**Planning & Zoning Commission
Agenda
Wednesday, January 18, 2023, 7:00 p.m.
Kirkwood City Hall
139 S. Kirkwood Road
Kirkwood, MO 63122
Posted January 13, 2023**

**CITY OF KIRKWOOD
PLANNING AND ZONING COMMISSION
SUBCOMMITTEE REPORT
JANUARY 18, 2023**

ACTION REQUESTED: SPECIAL USE PERMIT (VEHICLE SALE AND RENTAL) AND MAJOR SITE PLAN REVIEW – AUDI KIRKWOOD

Re: Audi Kirkwood – Site Plan Review (Major) & Special Use Permit

C1.0

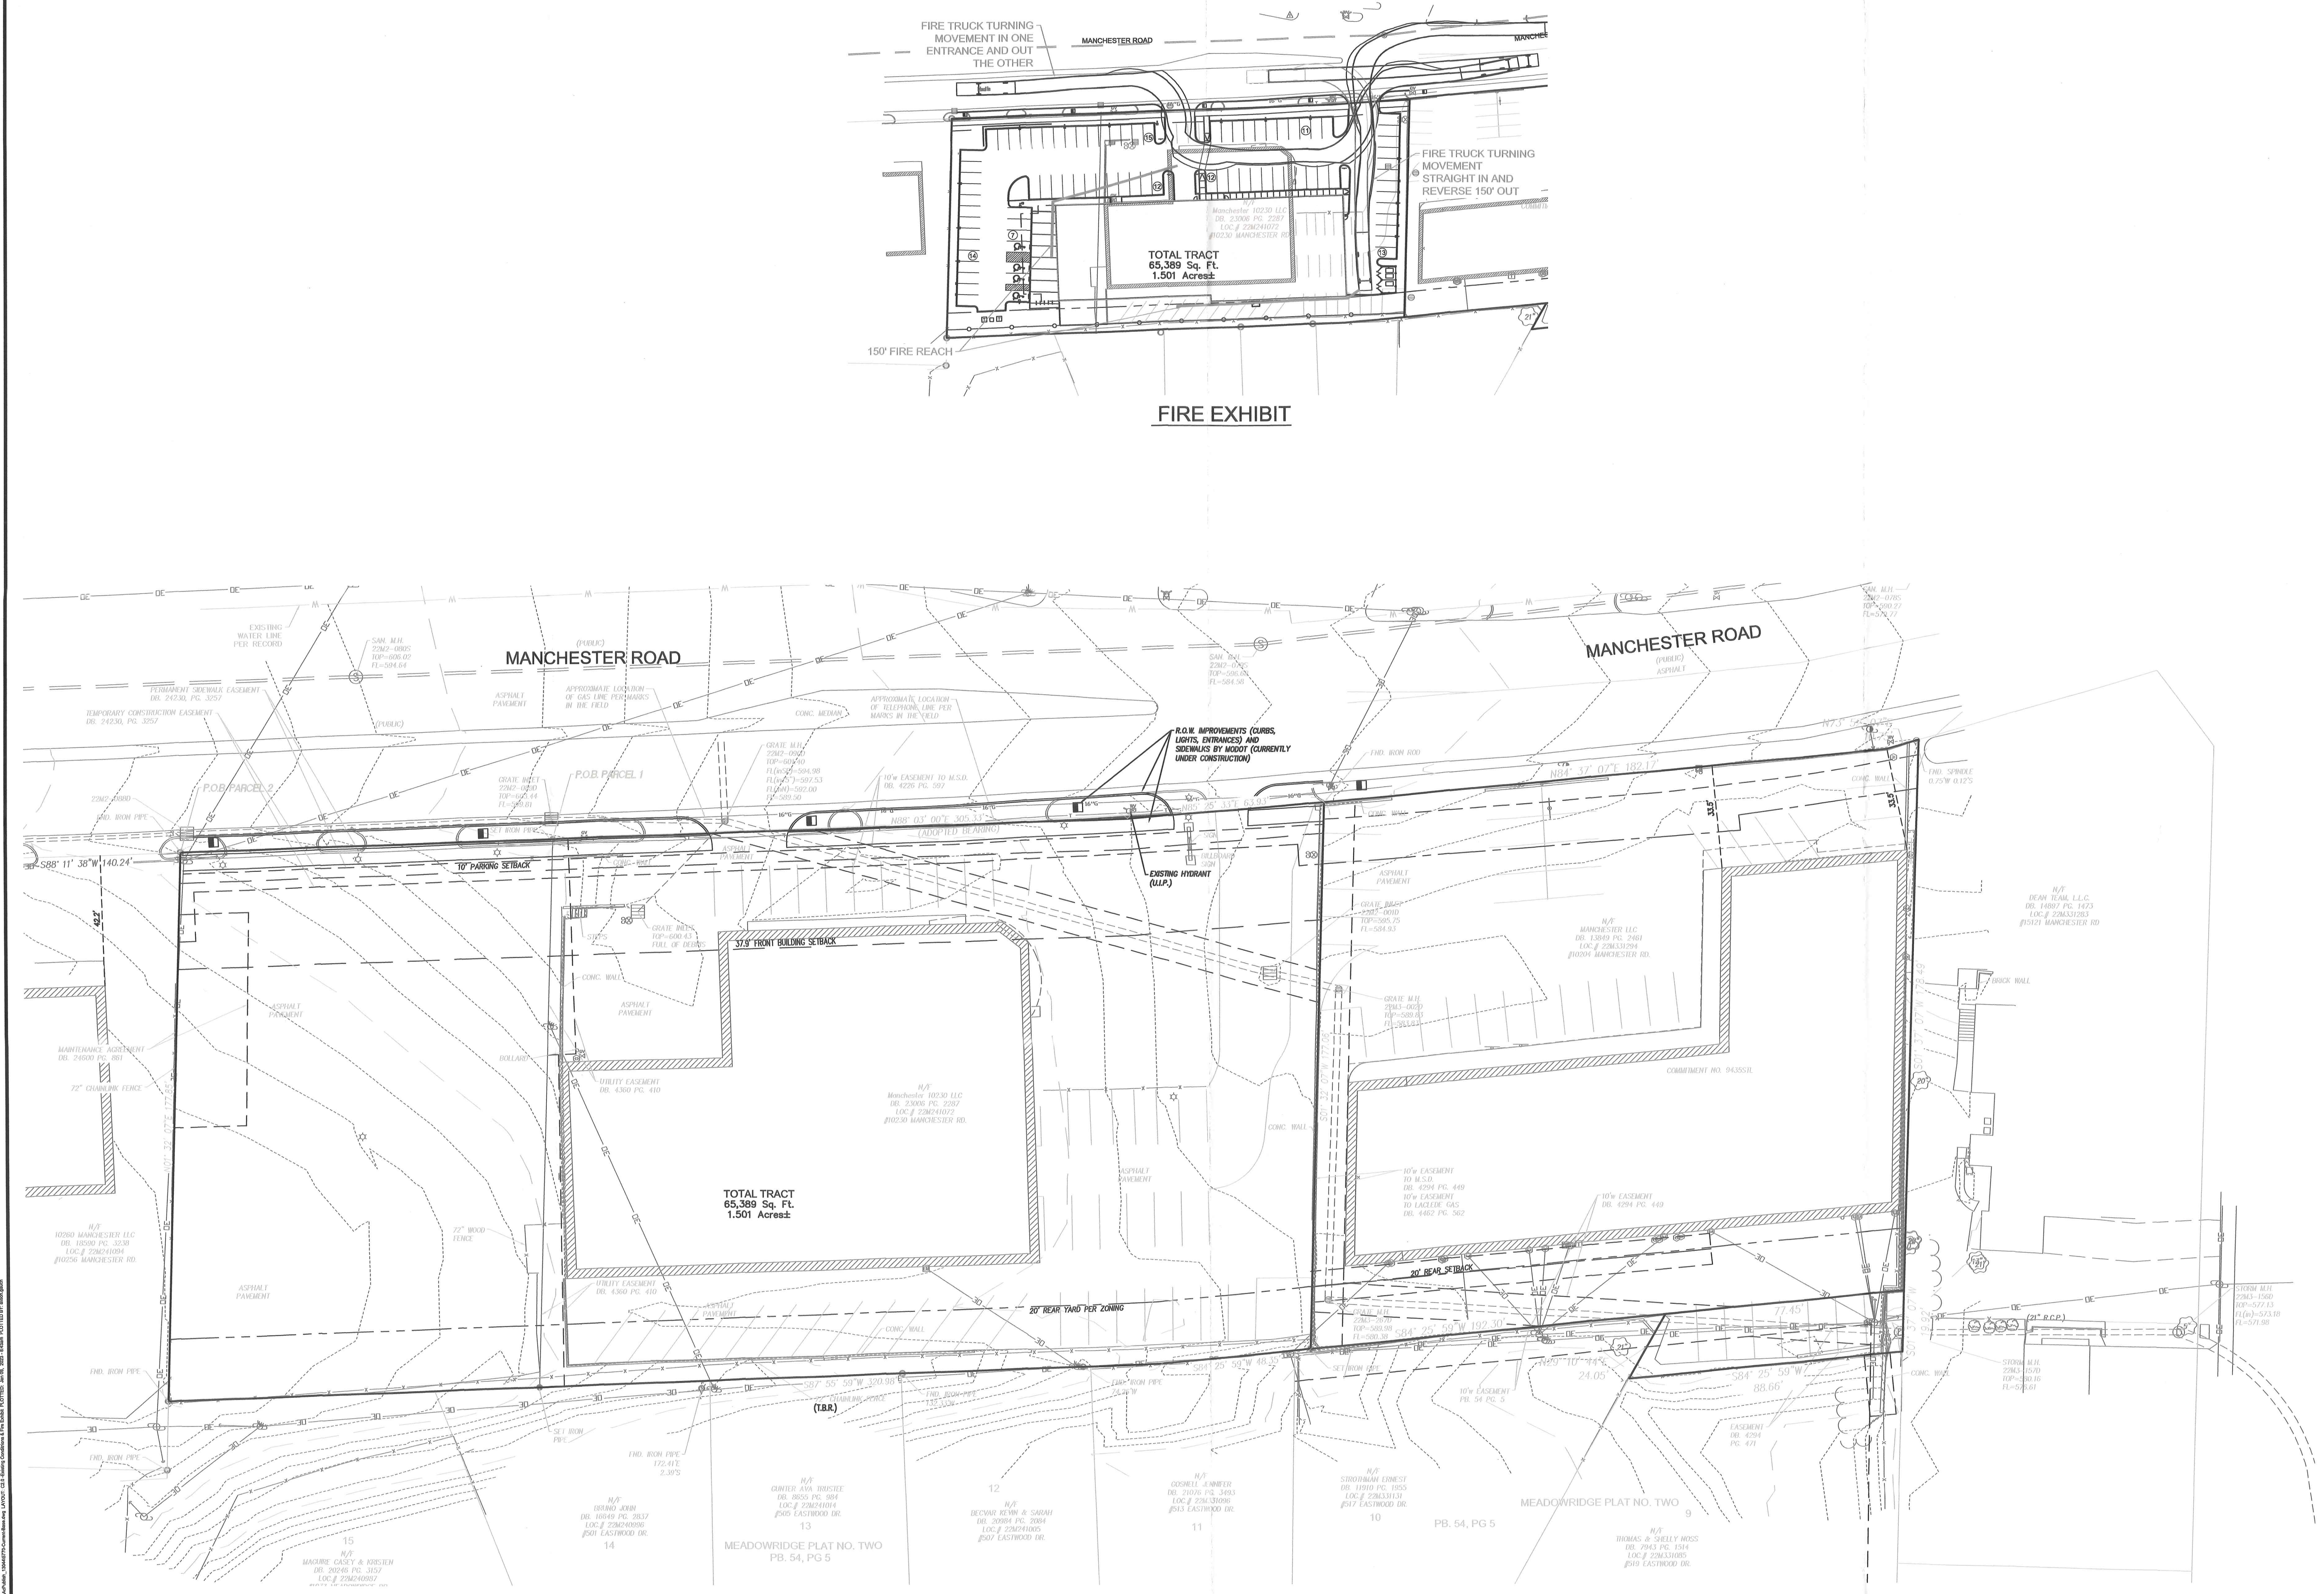
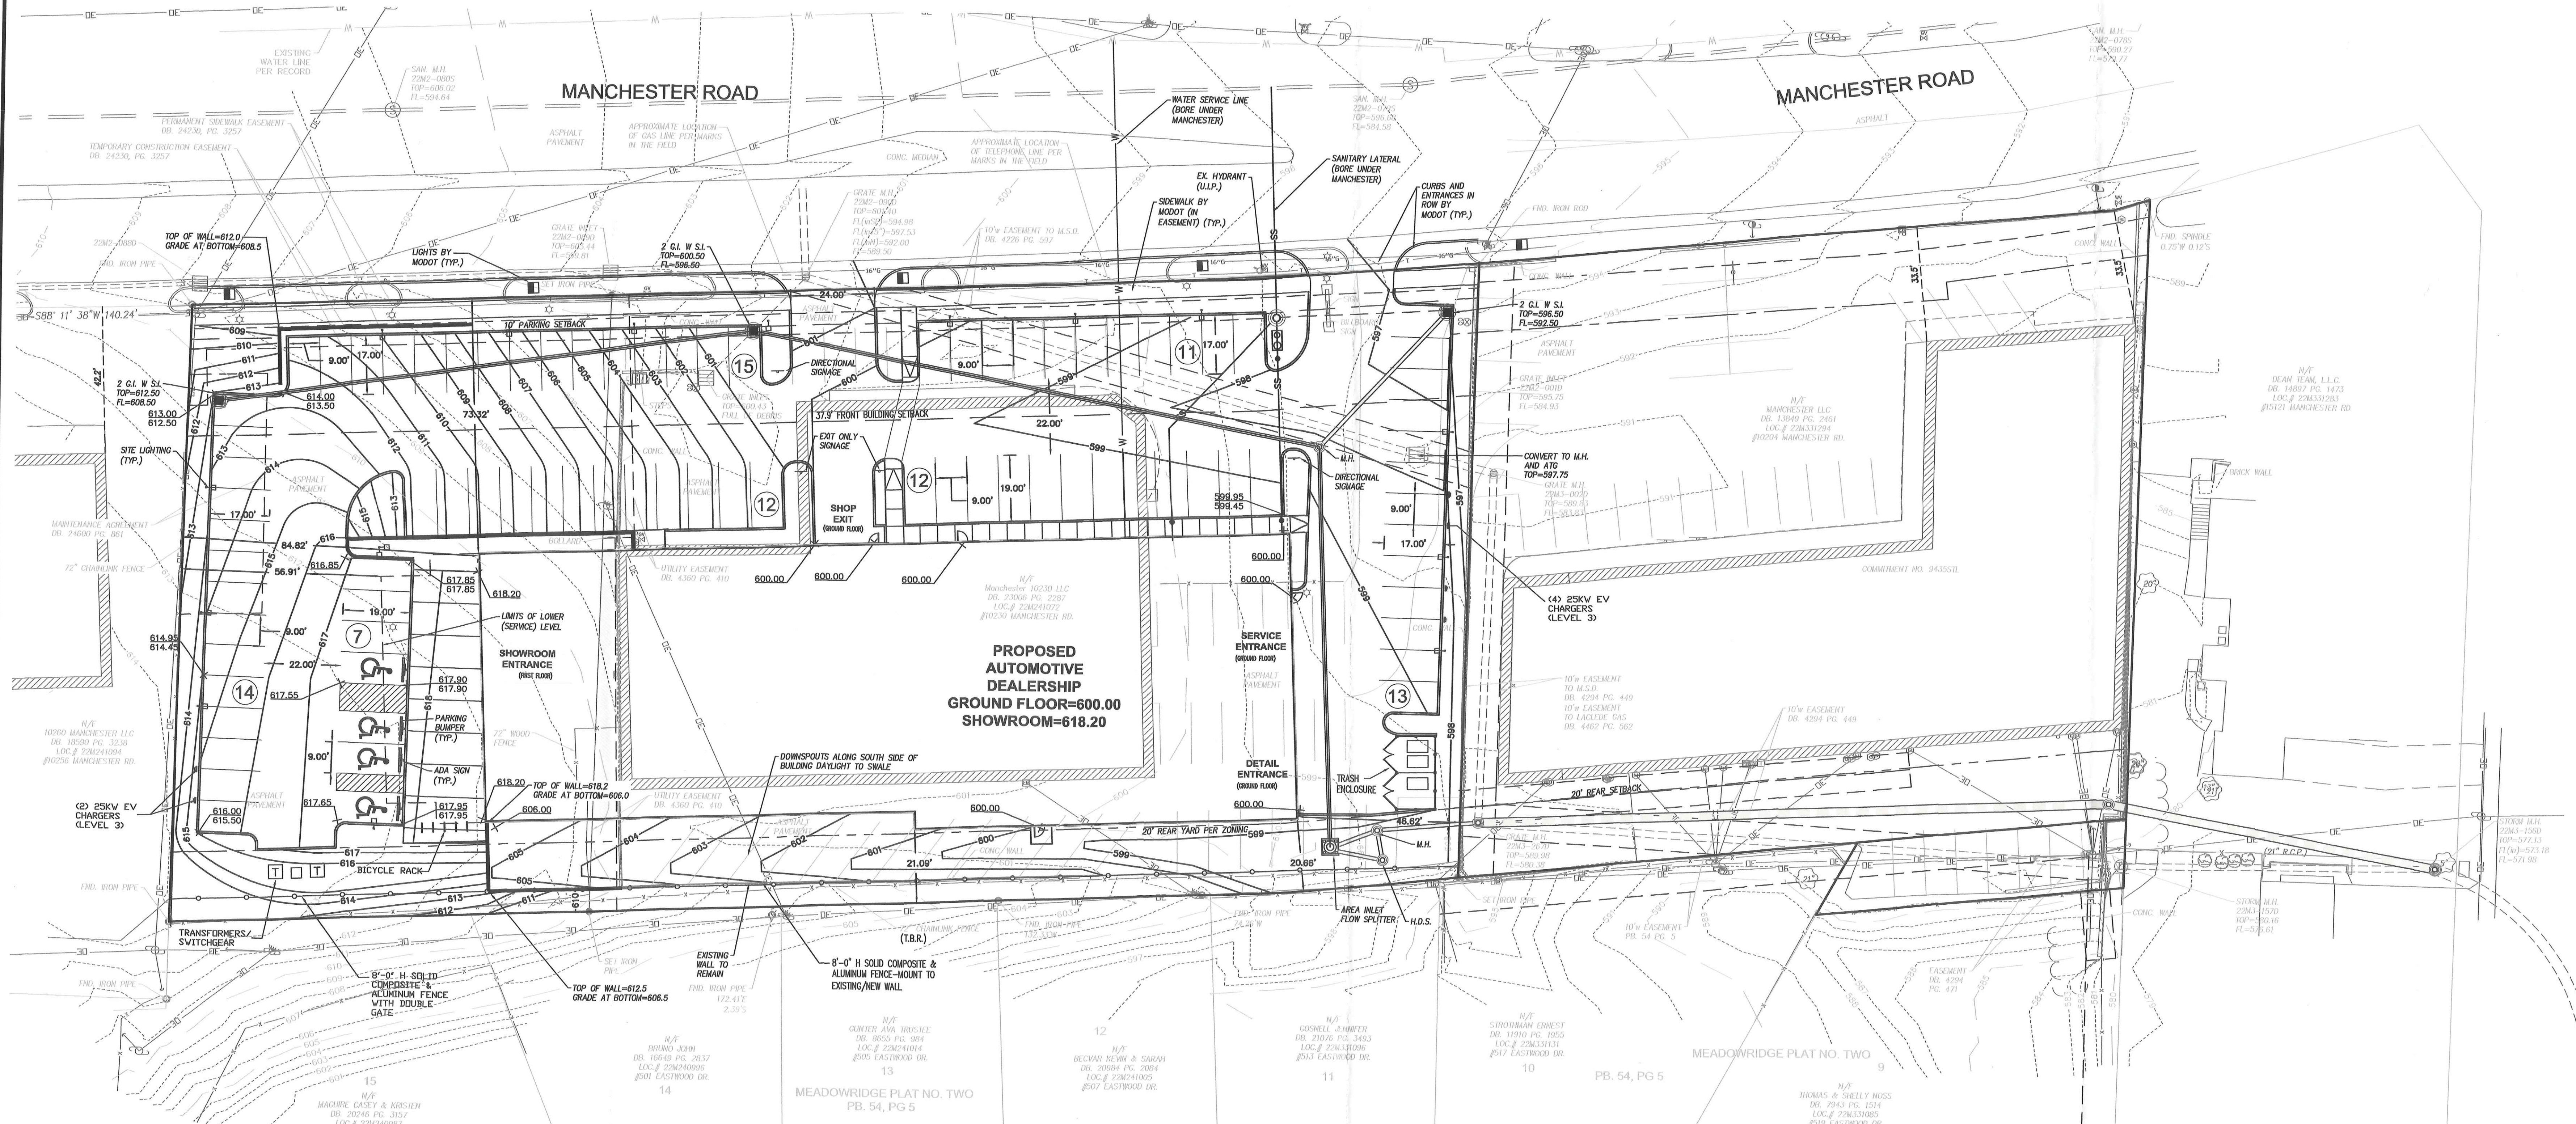
4. Two electric transformers will be installed on the southwest of the site and the site plan will be revised to reflect this and resubmitted.
5. The topography of the site was discussed with relation to the building's design and its utilization of the existing grade changes within the site. The building height will be about 40'.
